**TOWN OF NEWBURGH
PLANNING BOARD
TECHNICAL REVIEW COMMENTS**

PROJECT NAME: TARBEN II SUBDIVISION
PROJECT NO.: 2021-18
PROJECT LOCATION: SECTION 127, BLOCK 1, LOT 12
REVIEW DATE: 11 APRIL 2024
MEETING DATE: 18 APRIL 2024
PROJECT REPRESENTATIVE: JOHNATHAN CELLA, P.E.

PROPOSED TWO (2) LOT RESIDENTIAL SUBDIVISION FOR: LYNN WARREN TARBEN WAY LOT # 12 FILED MAP 274.16 (S/B/L: 127 - 1 - 12) TOWN OF NEWBURGH ORANGE COUNTY, NEW YORK TOWN OF NEWBURGH APPLICATION # 21-18

SURVEY SHEET

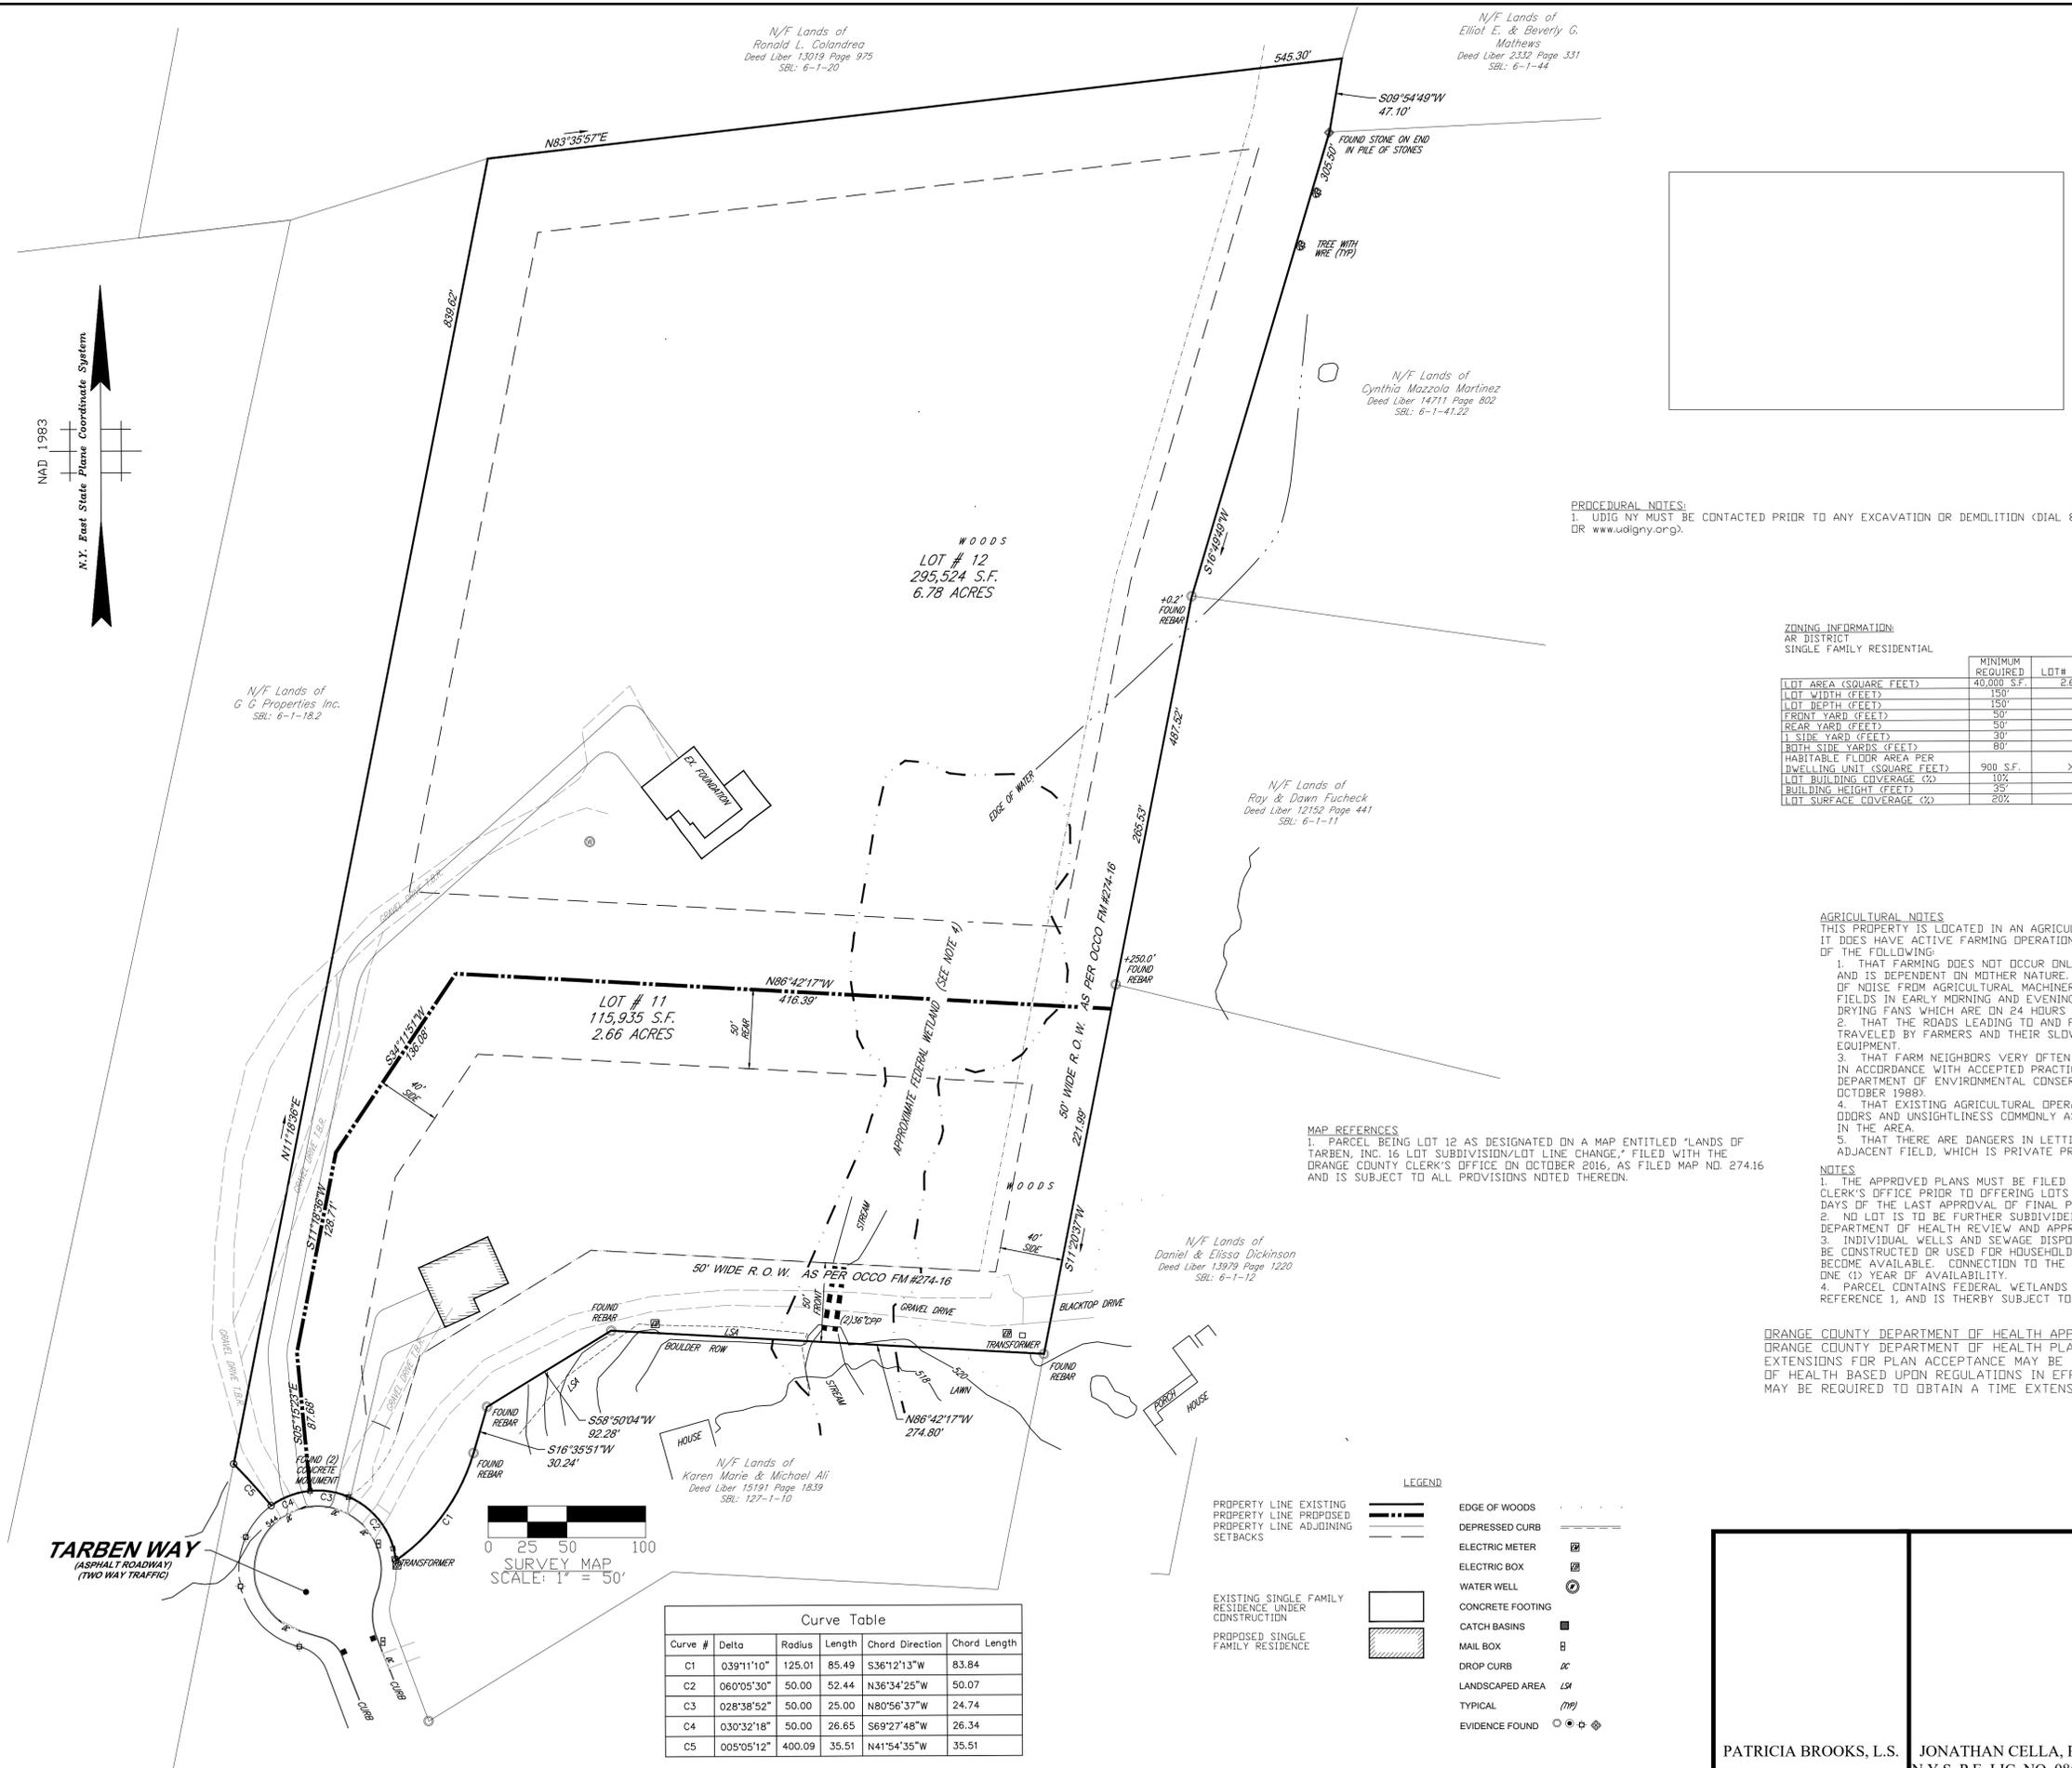
10. The gravel drive to the proposed house on Lot 11 is identified as "to be removed" on Sheet 1 of 5.
11. The size of the driveway culverst should be depicted on the plans.
